# PLATFORM

**Re: Responses to PC 11.7.19 meeting comments**

We are attaching the following comments issued after our PC hearing on Nov 7<sup>th</sup>, 2019, with responses on how the design team has addressed the comment by the Planning Commissioners.

**Address:** 450 1<sup>st</sup> St., Los Altos, CA 94022  
**Site Area:** 15,217 s.f. (0.35 acre)  
**Existing Dwelling Units:** 0  
**General Plan Designation:** Downtown Commercial  
**Zoning Designation:** Commercial Downtown / Multiple-Family (CD/R3)  
**Current Use:** Commercial Office

# SUBTERRANEAN LEVEL 1 PARKING GARAGE

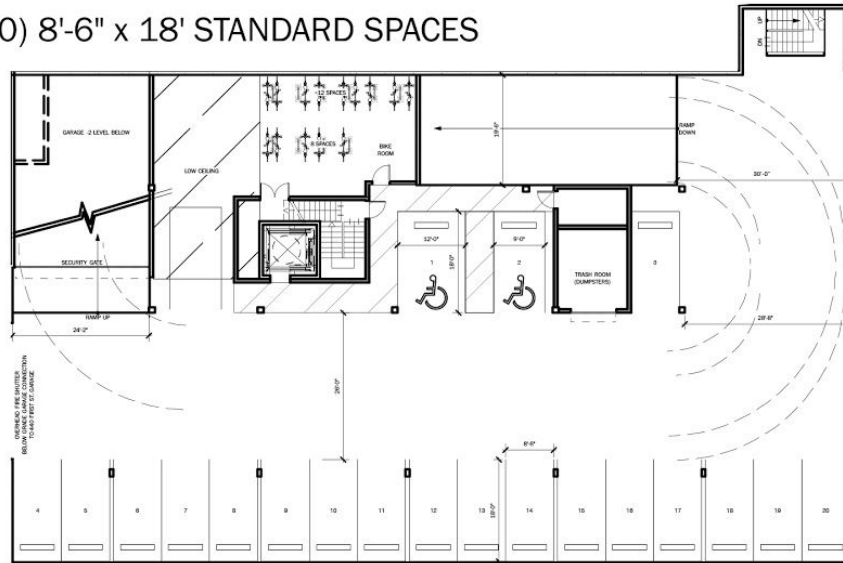
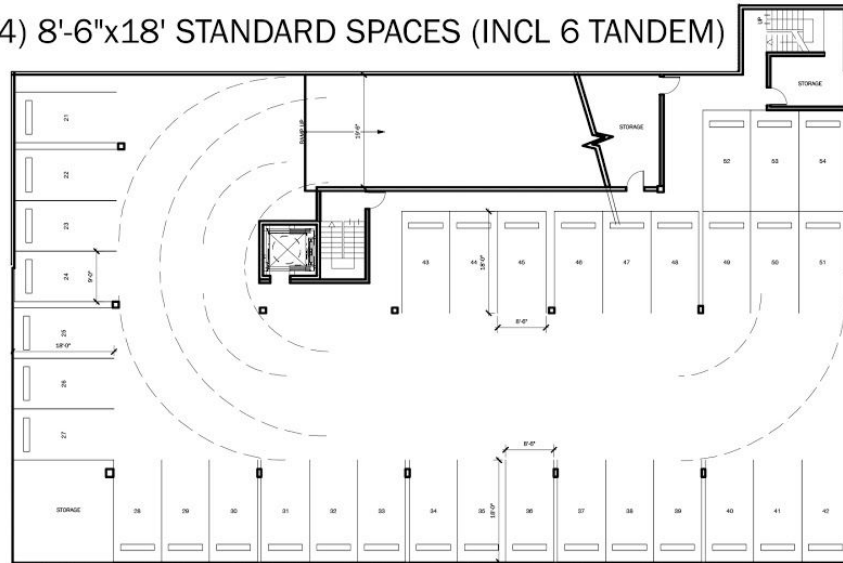
**9. Explore using 8.5-foot wide parking spaces, strongly encourage this to be supported as a waiver if it results in more parking.**

We have revised the garage layout to use an 8.5' spacing and this may result in additional spaces pending final coordination of garage structural and MEP drawings.

(20) 8'-6" x 18' STANDARD SPACES

(34) 8'-6"x18' STANDARD SPACES (INCL 6 TANDEM)
